# **ACCESS REPORT**

**STATE SIGNIFICANT DEVELOPMENT APPLICATION**

**FRASERS BROADWAY – BLOCK 1**

**20-102 BROADWAY  
SYDNEY**

**External Pathway Links and Building Entrances (Parts D3.2 & D3.3 of the BCA)**

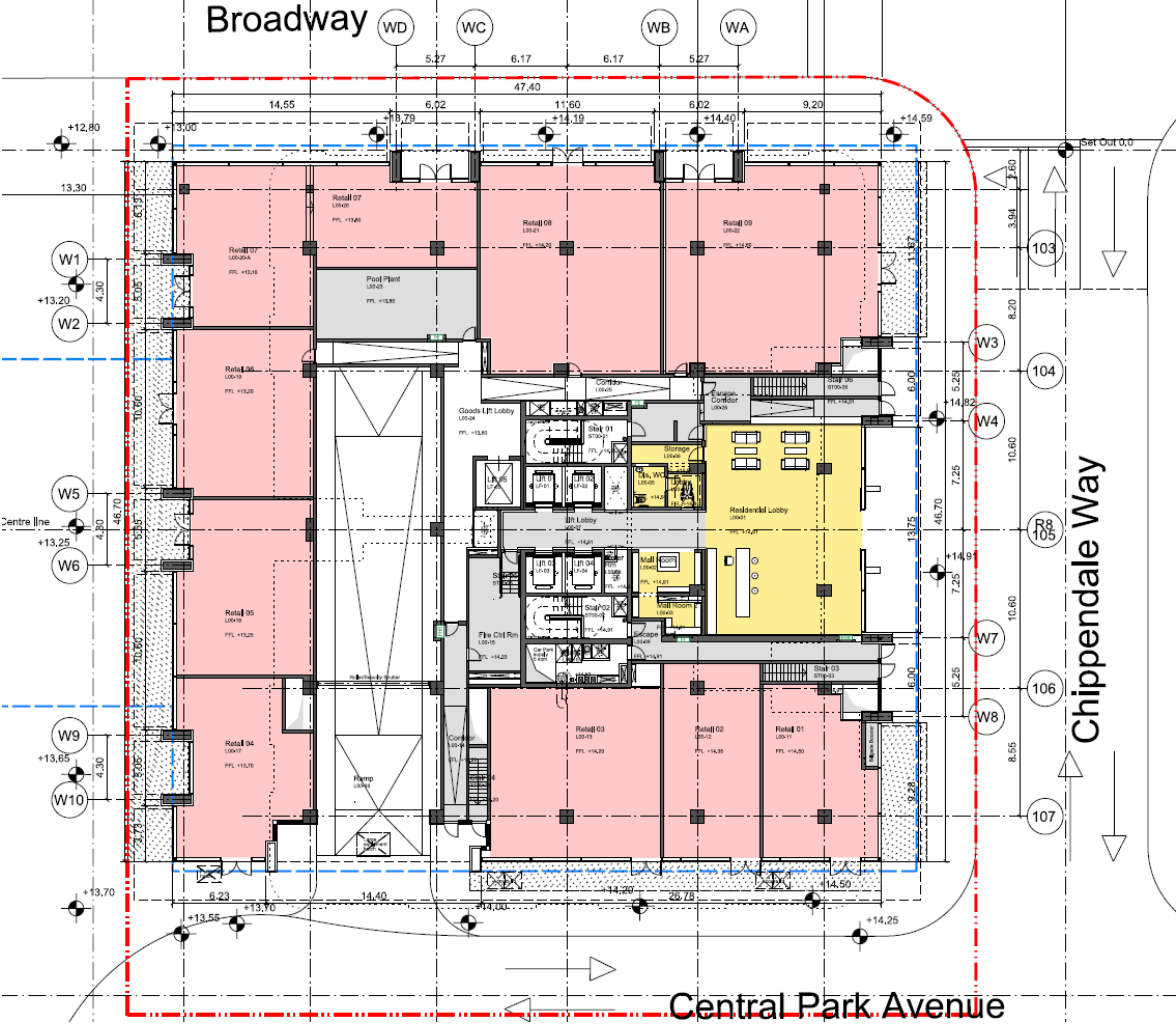
BCA & DDA Access Code Review	Complies
<p>I. <b>Street Frontage Retail &amp; Building Entrances</b> – The plans show several retail tenancies at street level. Site access to these tenancies and building entrances shall be provided in the following manner:</p> <ul style="list-style-type: none"> <li>• Chippendale Way footpath approaches propose on-grade almost level access to the Apartment Lobby @RL14.910 and Retail 09 @RL14.600 which reflects the topography of the public domain and thereby enables equitable access.</li> <li>• Central Park Avenue footpath approaches propose on-grade access to the retail tenancies 01, 02, 03, 04 @RL14.500 to 13.700 which reflects the topography of the public domain and thereby enables equitable access.</li> <li>• Southern public domain accessway approaches propose on-grade access to the retail tenancies 05, 06, 07 @RL13.250 to 13.160 which reflects the topography of the public domain and thereby enables equitable access.</li> <li>• Broadway footpath approaches propose on-grade access to the retail tenancies 07, 08, 09 @RL13.800 to 14.600 which reflects the topography of</li> </ul>	<p><b>YES</b></p> <p><b>YES</b></p> <p><b>YES</b></p> <p><b>YES</b></p>

BCA & DDA Access Code Review	Complies
the public domain and thereby enables equitable access.

<p>2. With regard to doorway circulation space the plans indicate doors which facilitate appropriate circulation space to comply with ASI428.1 and Parts D3.2 and D3.3 of the BCA.</p> <p>3. Subject to details of door schedule and door hardware to provide 850mm clear opening widths with lever and D-pull handles the development will comply with ASI428.1 and Parts D3.2 and D3.3 of the BCA.</p>	<p><b>YES</b></p> <p><b>YES at Cc stage</b></p>

### ***Internal Accessways (Part D3.3 of the BCA)***

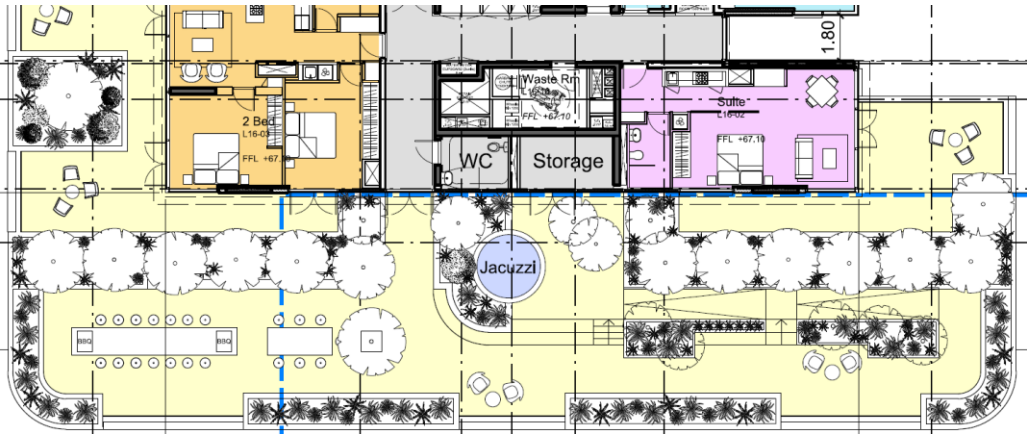
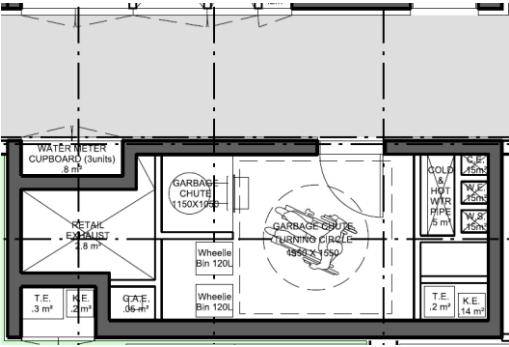
BCA & DDA Access Code Review	Complies
10. <b>Ground Floor Retail</b> – The base building plan for the ground floor retail tenancies provide open plan layouts with no inherent access barriers and will enable internal accessways and doorway circulation spaces to comply with AS1428.1 and satisfy Part D3.3 of the BCA, except for Retail 07 which is a split level. 11. <b>Retail 07</b> proposes a split level arrangement with two accessible doorways to access each level to facilitate equitable access to all areas and satisfy Part D3.3 of the BCA. 12. Future DA's shall be prepared relating to the internal fitout of the tenancies. 13. The plans also illustrated ramped access from the Goods Lift to several tenancies.	<p style="text-align: center;"><b>YES</b></p> <p style="text-align: center;"><b>YES</b></p>

**Lifts (Part E3.6 of the BCA)**

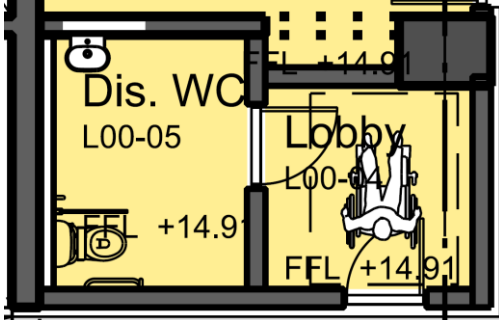
BCA & DDA Access Code Review		Complies
<p>27. While the development provides lifts that comply with Part D3.3 BCA in enabling vertical access to various details of internal floor car areas, controls, handrails and the like will be provided at construction documentation stage to confirm compliance with Part E3.6 of the BCA.</p>		<p><b>YES</b></p>
<p>28. In accordance with Part E3 of the BCA the passenger lift cars shall provide a 1400 X 2000 minimum area.</p>		<p><b>YES at CC stage</b></p>

*Example layout of B03 which illustrates 14 accessible parking spaces clustered around the lift core on level surfaces*

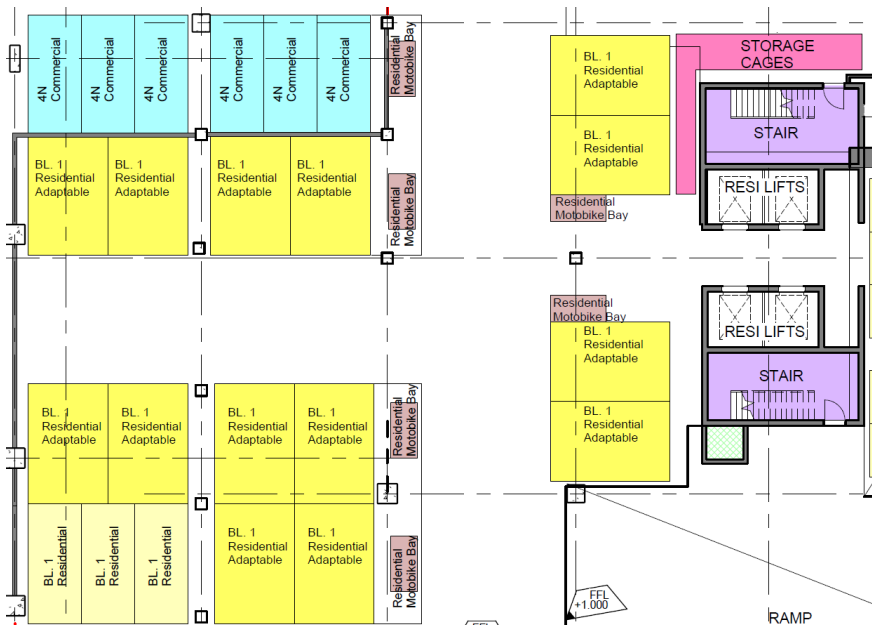
Cls 3.3.3, 3.7 & AS2890.5 The development proposes a five level basement carpark which is to be shared with Block 4N. **YES**  
 With respect to **Block I Residential** the carpark proposes 195 residential apartment spaces including 42 X 3800mm spaces for the adaptable apartments to satisfy AS4299

The basement layout of the adaptable apartment parking is consistent with the intent of the Sydney DCP 2012.

The accessible 2300mm minimum height clearances and 2500mm height over the accessible spaces will readily comply with AS4299, Council’s DCP 2012 for accessible parking.

The accessible parking will be situated on generally level pavement no steeper than 1:40 to comply with AS2890.6.

The locations of the accessible parking adjacent the lift landings are convenient and enable direct access to the lift landings,

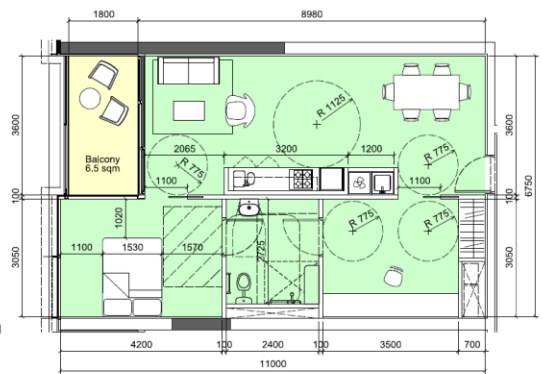
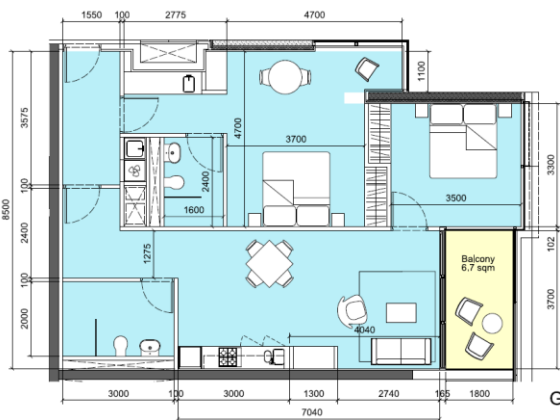
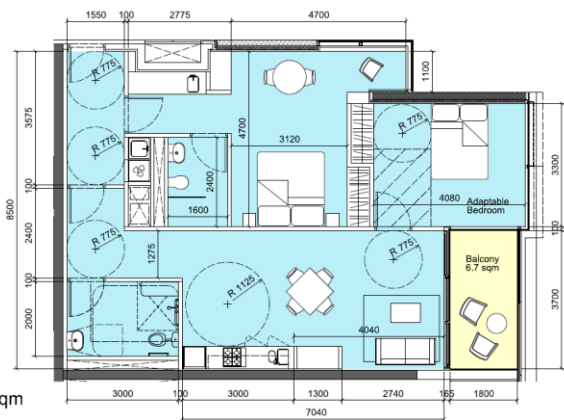
AS4299	<p><b>Accessible entry</b> – The front entrances to these units provide at least 1600mm X 1600mm externally in the common corridors and internally with 530mm minimum latch side clearance, which complies with the spatial requirements of AS4299.</p> <p>Internally the 1600mm wide entry foyers provide the required 1600mm X 1600mm minimum circulation area with 530mm minimum latchside clearance and a 950mm door.</p>	<p><b>YES</b></p> <p><b>YES</b></p>
--------	---	-------------------------------------

AS4299  
Cls 4.3.7 **Interior: general** – The pre adaptation plans provide an open plan living area with direct access to the bedroom doorways of several apartment types in accordance with ASI428.1/4299. **YES**

While the plans do not indicate 950mm external door widths, 870mm internal door widths and lever handles these details should be provided at construction drawing stage to confirm compliance. **YES**

AS4299  
Clause 4.7 **Living and Dining rooms** – The plans show combined living and dining areas on a single level with sufficient area to provide a 2250mm diameter turning area to comply with this clause. **YES**

AS4299  
Clause 4.5 **Kitchen** – The adaptable apartments provide a single galley kitchen in an open plan design. **YES**

The single galley kitchen designs inherently provide the required 1550mm X 1550mm minimum circulation space adjacent the benches to comply with AS4299 requirements. **YES**

With regard to the “adaptability” of the kitchen the pre-adaptation plan provides an appropriate layout of sink, fridge, wall oven, cooktop while the post adaptation plan proposes a height adjustable workbench that is readily adaptable and satisfies the “ease of adaptation” guidelines outlined in section 2 – Performance Objectives of AS4299.

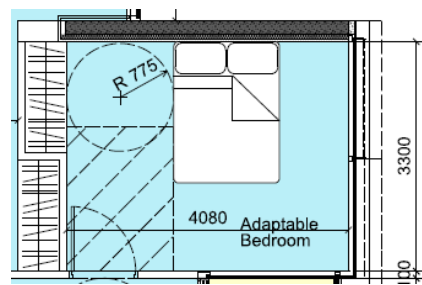
AS4299  
Clause 4.6 **Main bedroom** – The various post adaptation designs of the main bedrooms for these Units will provide 1540mm X 2070mm circulation space adjacent and at least 1000mm on alternate sides of a queen sized bed to satisfy AS4299/1428.

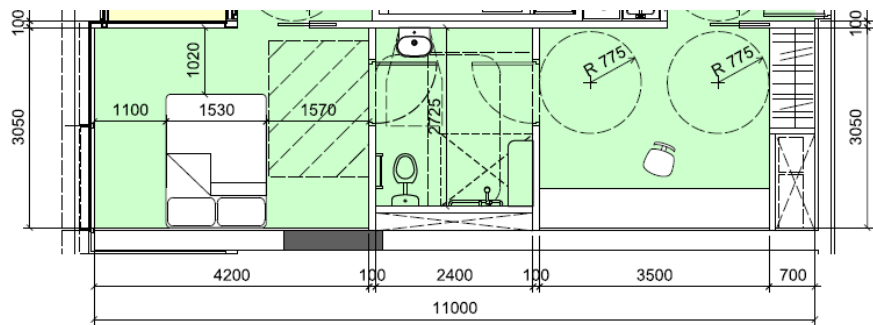
AS4299  
Clause 4.7 **Bathroom** – The plans for the various bathroom designs will be at least 2400mm X 2725mm or 2000mm X 3000mm with a layout of sanitary facilities that is readily adaptable to comply with ASI428/4299. **YES**

Clause	Adaptability Assessment –	Complies
	I am also satisfied that the location of the WC pan, washbasin and shower/bath in pre and post adaptation satisfy the performance requirements of AS4299.	
AS4299 Cls 4.4.3	<b>Toilet</b> – The size and layout of the bathrooms enable the toilet to comply with AS4299 by providing 1250mm X 900mm in front of the WC pan.	<b>YES</b>
AS4299 Clause 4.8	<b>Laundry</b> – The laundry closets shall provide adequate space for a washing machine/drier while the adjacent area facilitates the required minimum 1550mm X 1550mm clear circulation space in front of the appliances to comply with AS4299.	<b>YES</b>
AS4299 Cls 3.5(b)	<p><b>Outdoor Private Open Space</b> – The plans show outdoor balcony terrace areas adjacent living areas for each of these units with sliding doors for convenient access and adequate area to perform a 180 degree wheelchair manoeuvre.</p> <p>While the plans do not indicate thresholds the construction drawings will confirm a 35mm maximum with the capability for threshold ramps to comply with AS1428/4299.</p>	<b>YES</b>
